**NYSDOT**

**RE: SEQR – Mohawk Valley Health System  
Integrated Health Campus  
Draft Environmental Impact Statement**

As requested, the New York State Department of Transportation (NYSDOT) has reviewed the Draft Environmental Impact Statement (DEIS) including the Traffic Impact Study for the proposed Mohawk Valley Health System (MVHS) Integrated Health Campus to be located in downtown Utica. Upon review of the information provided, NYSDOT offers the following comments:

CONTRACT #1, POTTER STREET, STORM SEWER

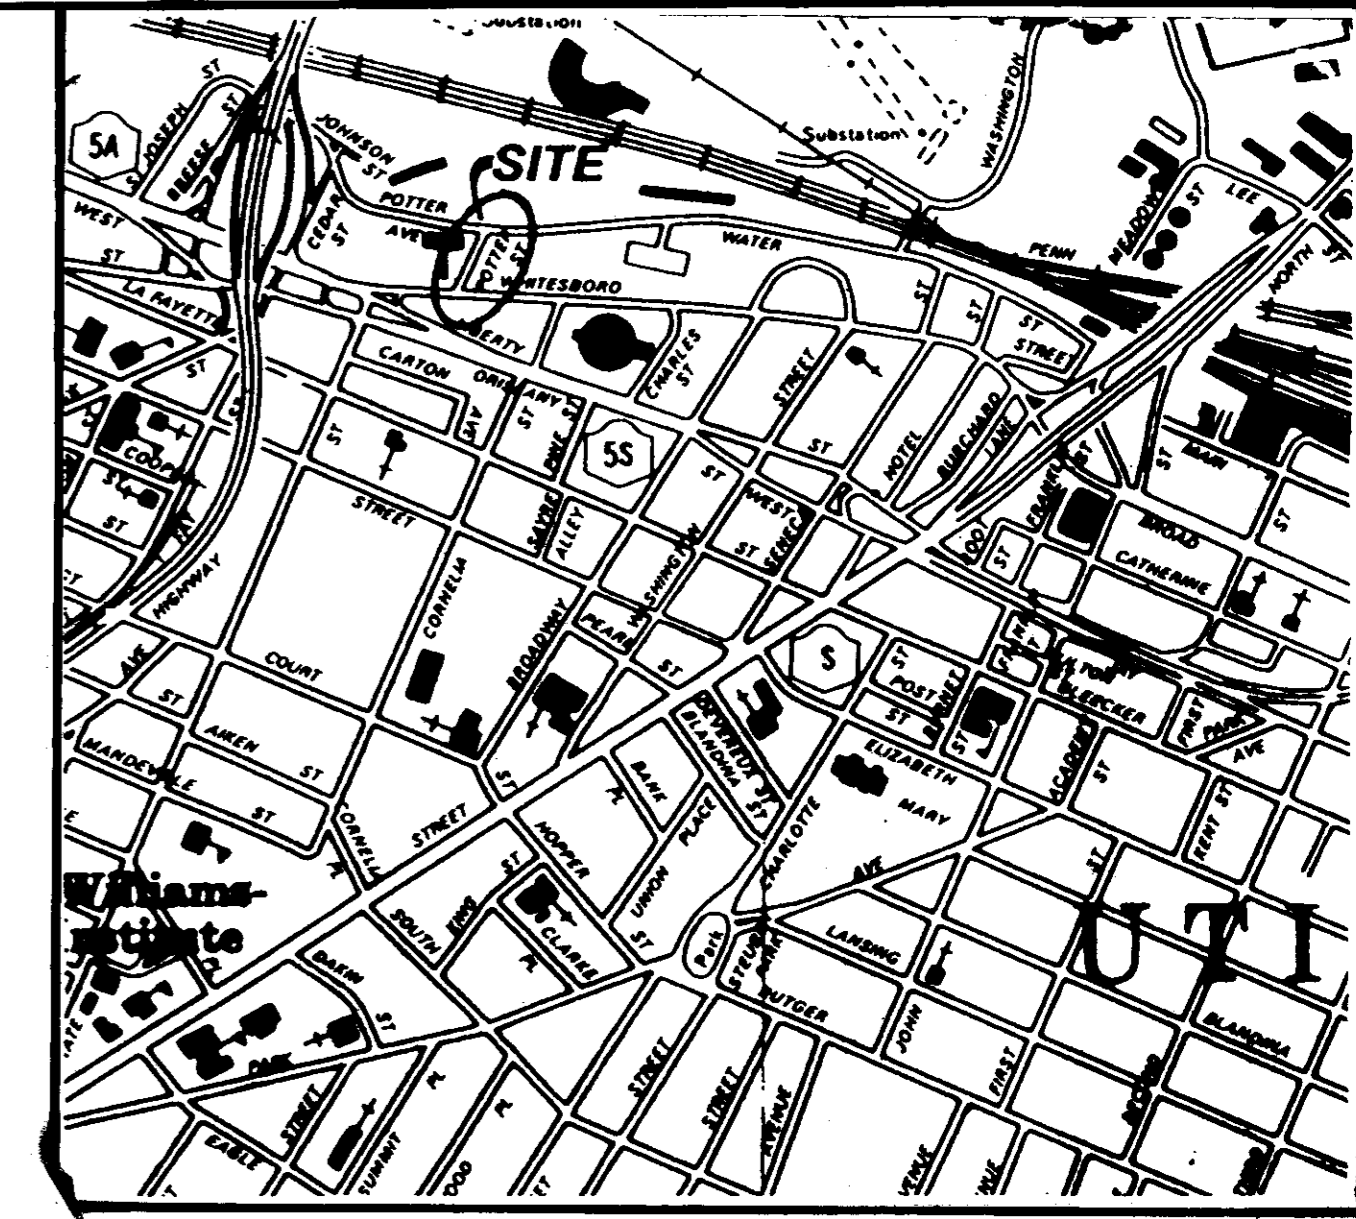
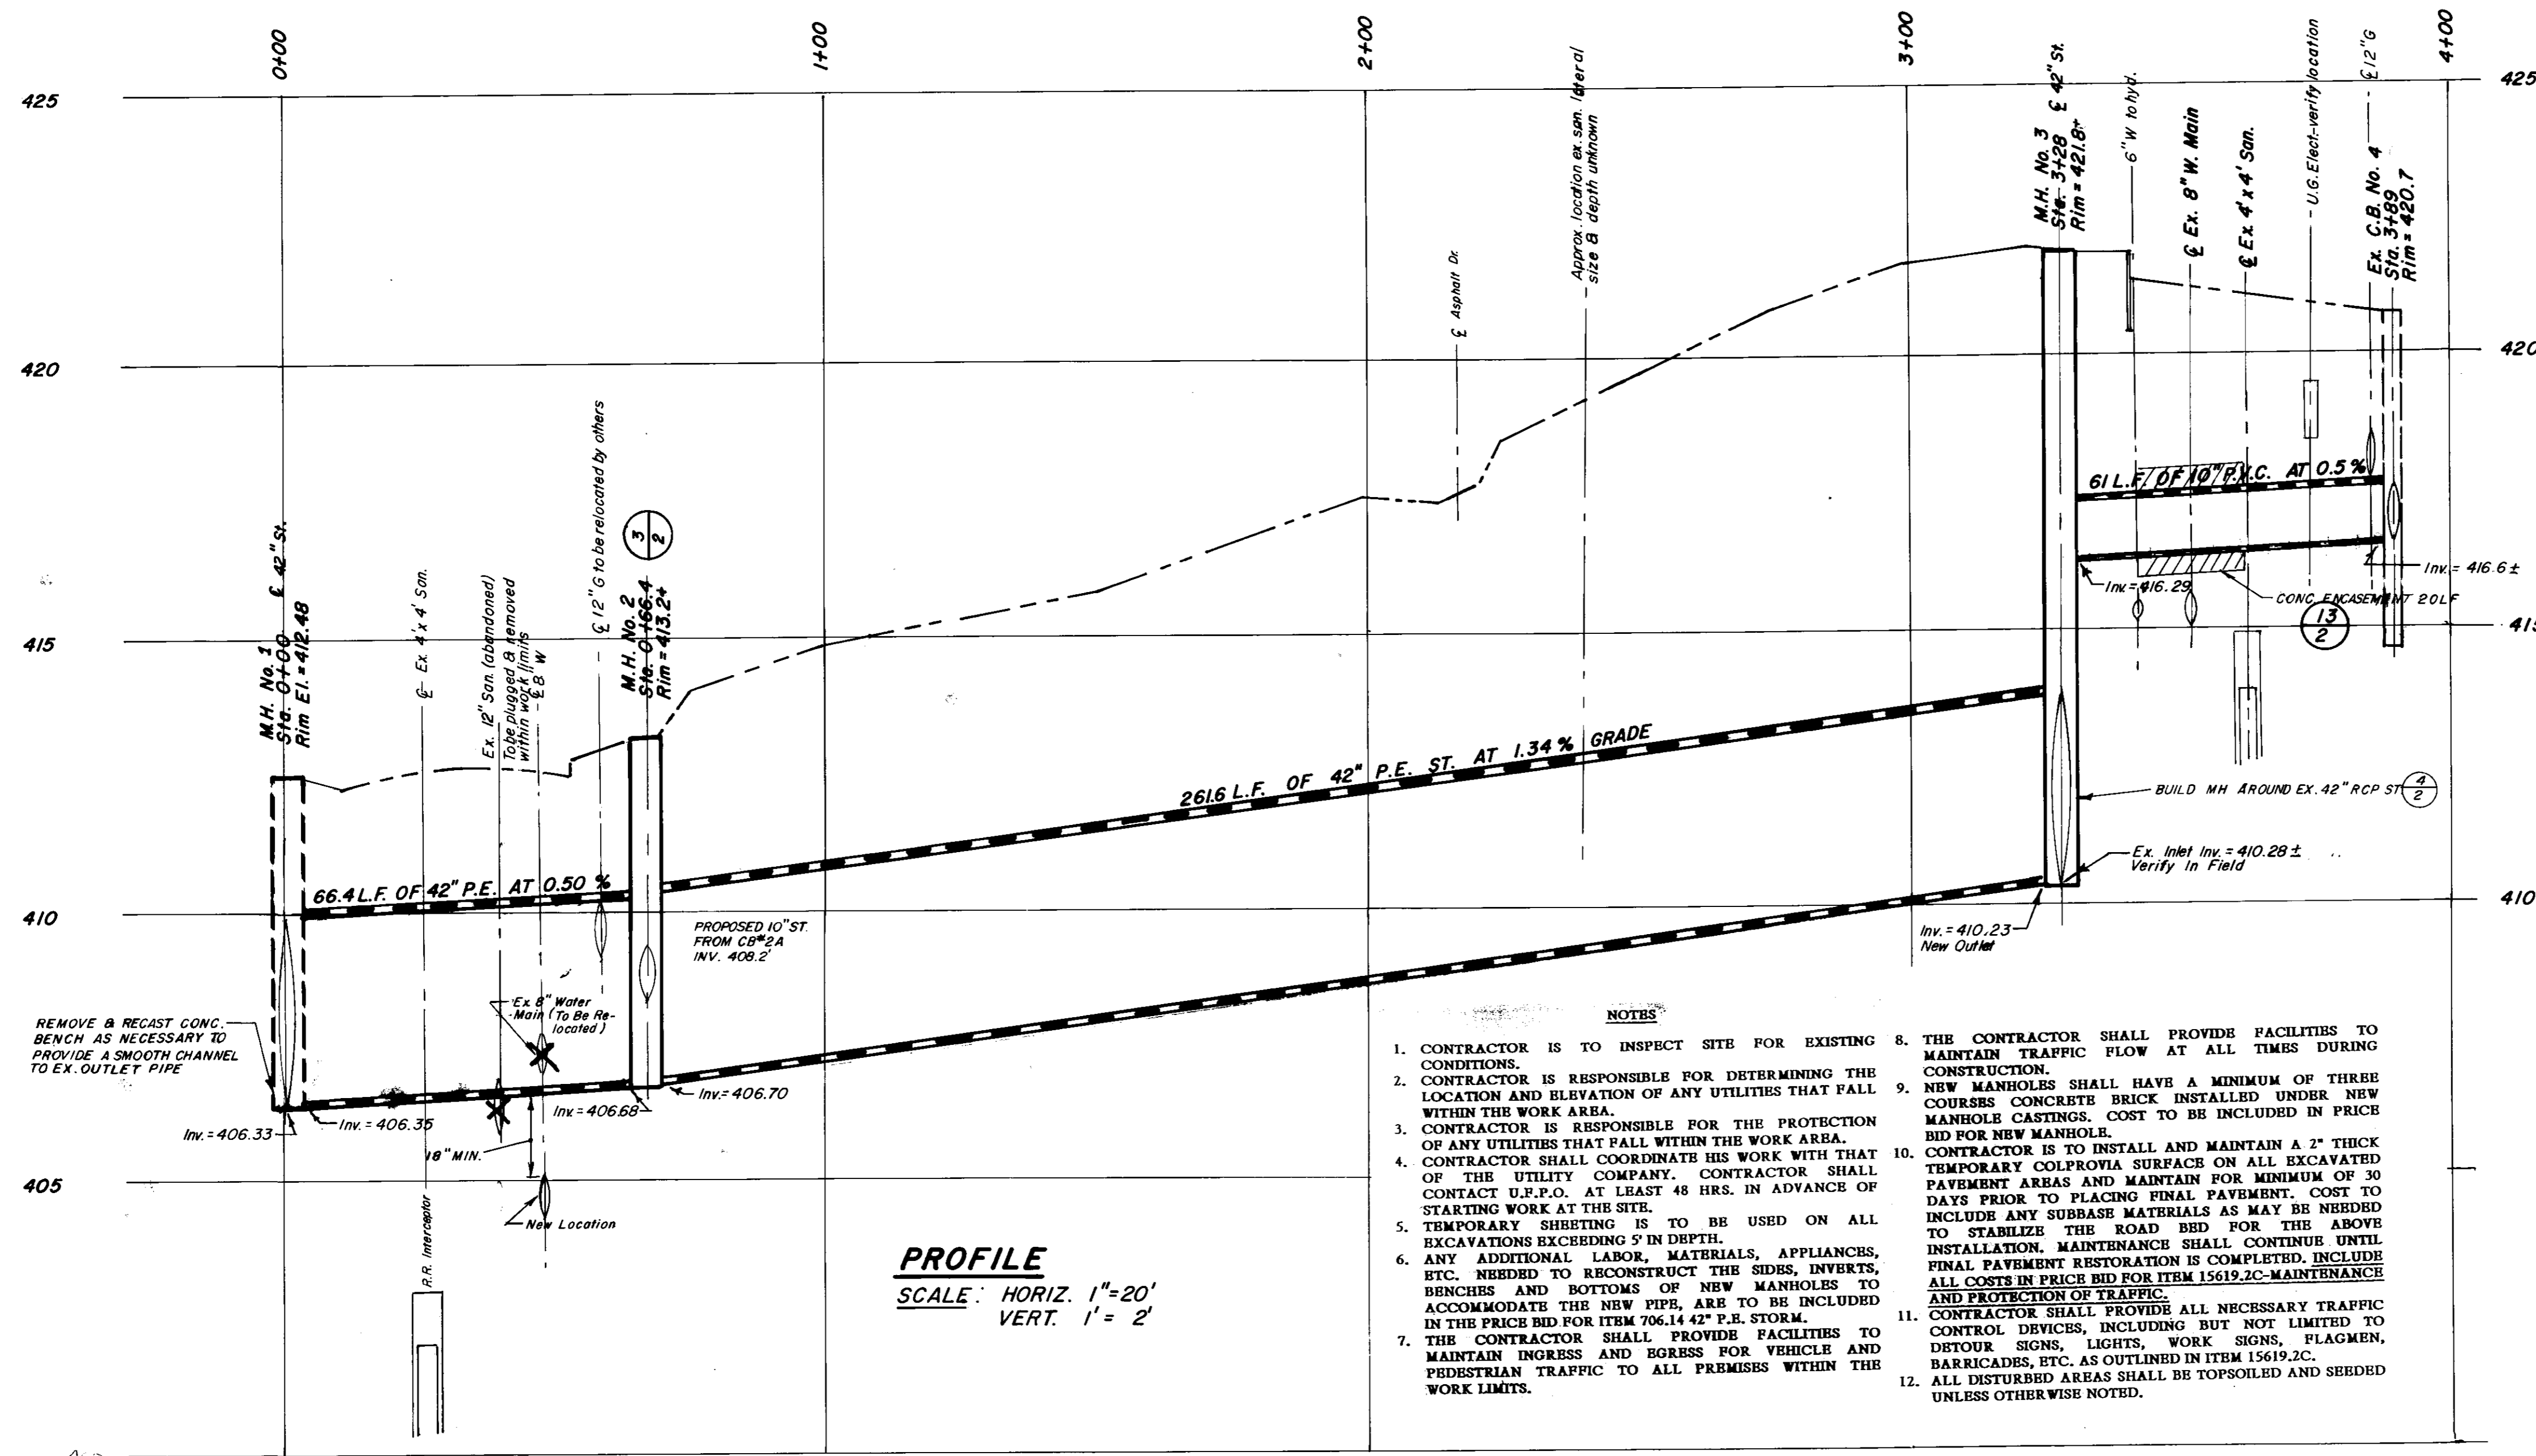
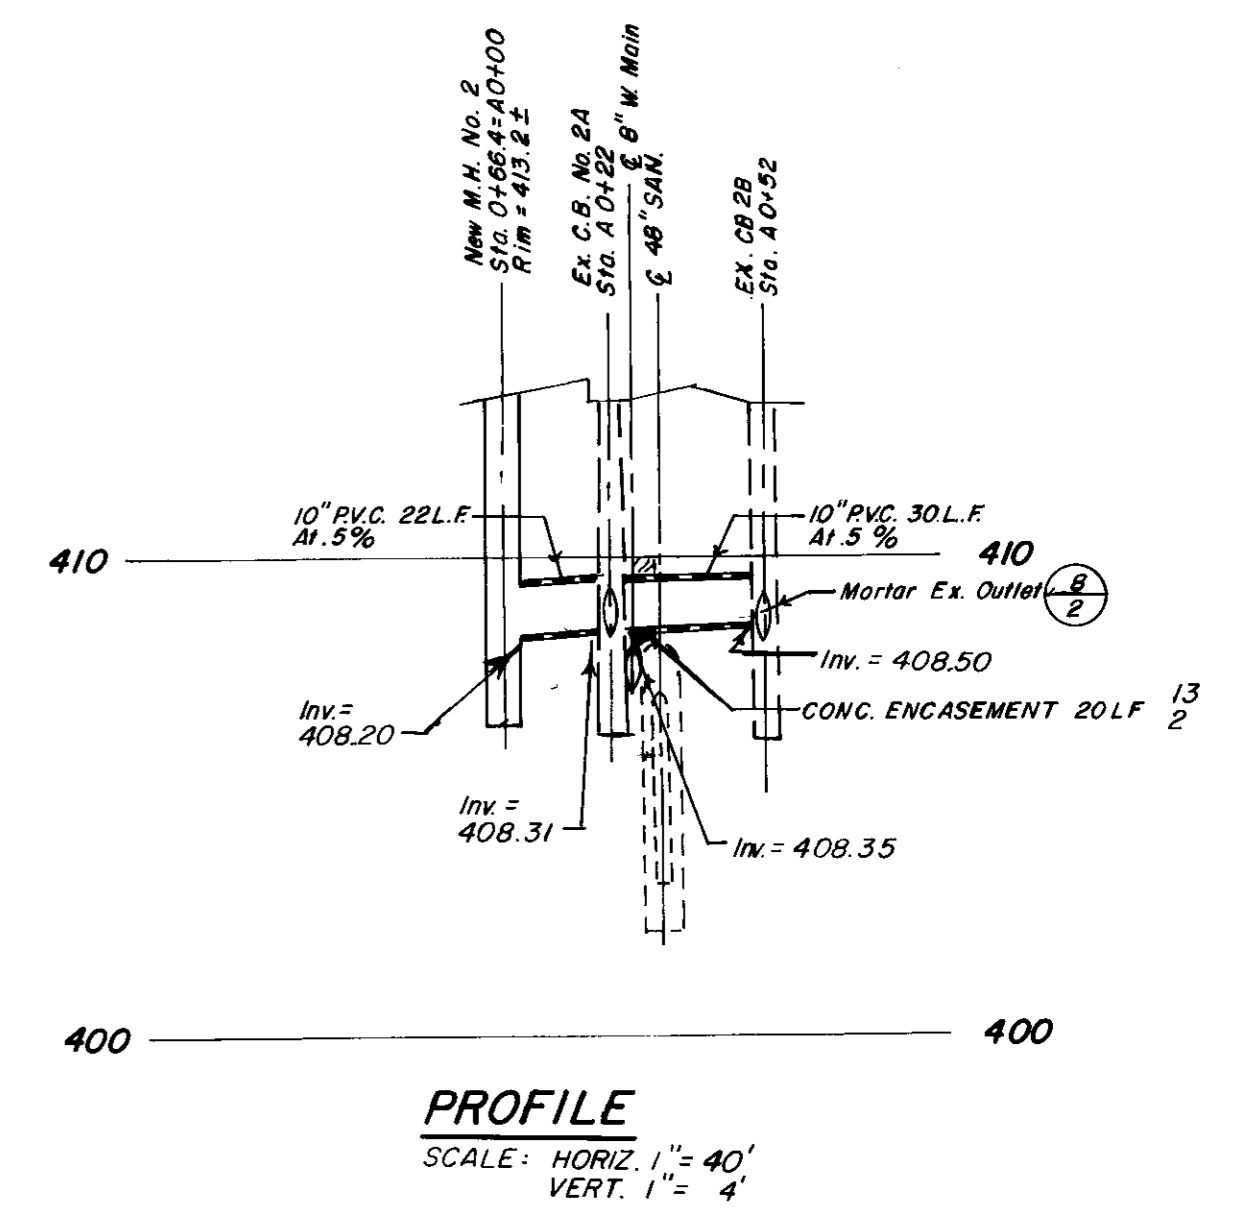
1. A Use & Occupancy permit from NYSDOT may be required for proposed parking lots adjacent to the North-South Arterial (NY 5/8/12).
2. Page 80, The existing Cornelia Street 42-inch line does not connect to the proposed outfall under CSX (A9.1) but follows Potter Street and Potter Ave under the CSX to the Mohawk via a 48-inch brick (see attached record plans provided by City of Utica). If the Cornelia Street outlet is used, a separated connection to the A9.1 proposal would be needed. Additionally, the 42-inch line that follows Auditorium Drive is not in the public right-of-way and may require acquisition for the Auditorium Authority.
3. The proposed A9.1 improvements are not shown on Figure 16.
4. Figure 17 – Existing & Proposed Water Mains. Proposed installation of a 12-inch water main along Oriskany Street East between State Street and Broadway if

1. A Use & Occupancy permit from NYSDOT may be required for proposed parking lots adjacent to the North-South Arterial (NY 5/8/12).
2. Page 80, The existing Cornelia Street 42-inch line does not connect to the proposed outfall under CSX (A9.1) but follows Potter Street and Potter Ave under the CSX to the Mohawk via a 48-inch brick (see attached record plans provided by City of Utica). If the Cornelia Street outlet is used, a separated connection to the A9.1 proposal would be needed. Additionally, the 42-inch line that follows Auditorium Drive is not in the public right-of-way and may require acquisition for the Auditorium Authority.
